CENWS-OD-TS-NR

MEMORANDUM FOR: RECORD

June 5, 2014

**SUBJECT:** DETERMINATION REGARDING THE SUITABILITY OF A **PORTION** OF PROPOSED DREDGED MATERIAL FROM THE MUKILTEO MULTIMODAL PROJECT, MUKILTEO, WASHINGTON, EVALUATED UNDER SECTION 404 OF THE CLEAN WATER ACT FOR UNCONFINED OPEN-WATER DISPOSAL AT THE PORT GARDNER NON-DISPERSIVE DISPOSAL SITE, OR FOR IN-WATER BENEFICIAL USE.

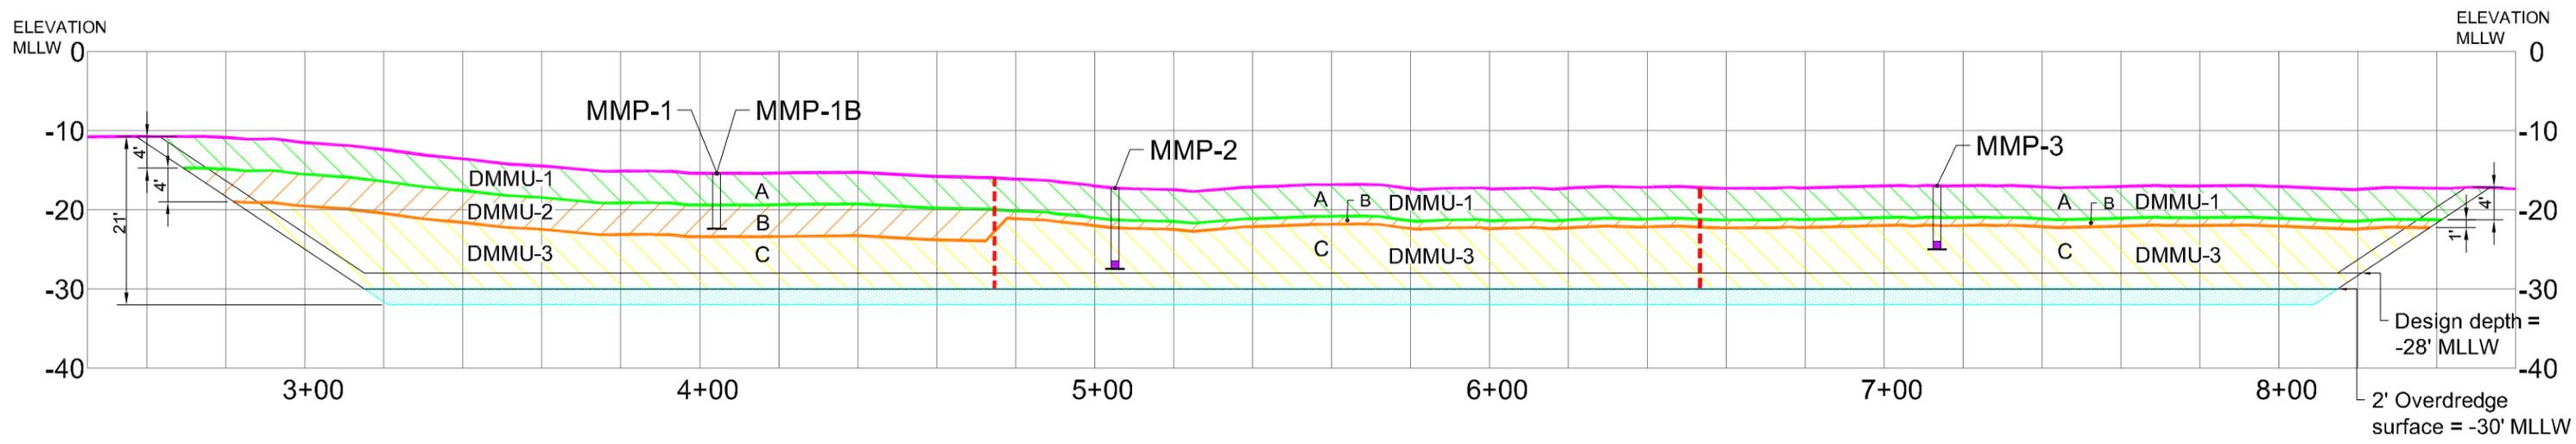
A new bathymetric survey was completed in January 2014 after draft characterization results were reported to the DMMP (BergerABAM, 2014a). The new bathymetry showed that the mudline of the dredge prism ranged from about -11 to -17 ft MLLW, with an estimated dredge volume of 21,000 cy. This change in bathymetry resulted in a changed thickness to DMMU-3, and showed that Z-layer depths were not achieved at any of the core locations (**Table 3, Figure 3**).

**Due to the sampling anomalies mentioned above, the data collected to date for this project are not sufficient to determine suitability for the entire project. Specifically, no sample was collected from the nearshore subunit of DMMU-3, and no samples were collected from the post-dredge surface. This memo documents only the suitability of those areas with sufficient data to make a determination of suitability for open-water disposal, or in-water beneficial use.**

8. **Additional Sampling in DMMU-3.** Proposed dredged material (approximately 2,800 cy) from the nearshore (southern) subunit of DMMU-3 must be characterized according to DMMP guidelines before suitability and antidegradation for this portion of the dredged material prism can be determined. DMMU-3 should be sampled in the vicinity of MMP-1. Close coordination with DMMO must take place on sample placement and core depth; core location may be adjusted to avoid debris but must be coordinated in real time with DMMO.
